5EF-MON17-04 (1)

From: Joe Kleckner <jkleckner@cheetahchassis.com>
Sent: Tuesday, April 18, 2017 11:24 AM
To: Eric.Bruins@inontime.com
Subject: Brake Chamber Mounting Position. 788999

Figure 2.4

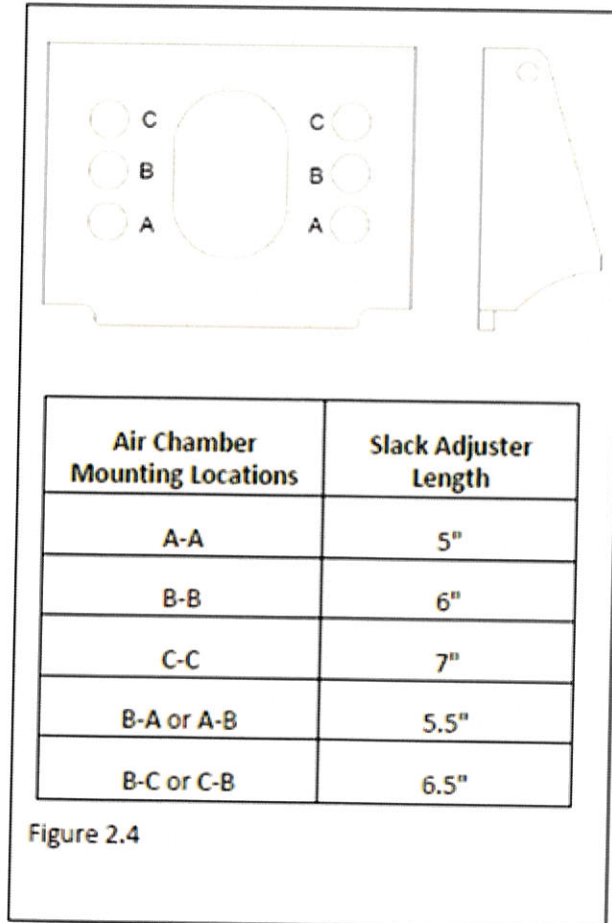
We need your assistance,
Serial number 788999, It does appear that the brake chambers may have been mounted in the incorrect position.

The below diagram show where the chambers should be mounted for the slack adjuster length.
Your chambers should be mounted in holes B-A or A-B

Can you please check your units to see if they are installed properly.
If they are not, Please let me know and we can make arrangements to get them fixed properly.

You can have your shop guys make these changes and submit a bill for the work.
Or we can make arrangements to get them to a shop to get fixed.

Install the air chamber in the mounting holes in the chamber bracket according to the slack adjuster length required. (Figure 2.4)
